LEVELING AND STABILIZATION

Fig. 1 Pressure to Open (2075 PSI) - Part # [142927](#)

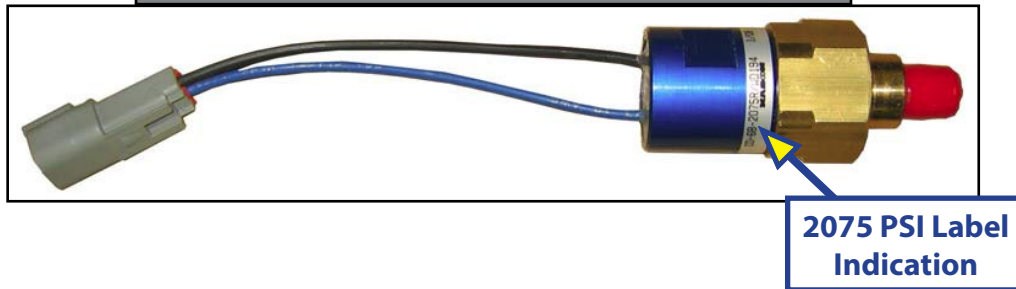
Rear jack(s) will not retract completely before system shuts down.

"JACKS DOWN" light goes out and system operates normally, rear jacks remain extended 3-6 inches.

System reaches peak pressure of 2075 PSI prior to jacks completely retracting.

Pressure switch opens and disconnects circuit; "JACKS DOWN" light goes out indicating jacks completely retracted.

Replace Pressure Switch [142927](#) with [159321](#).

Notice label on diagrams above to identify.
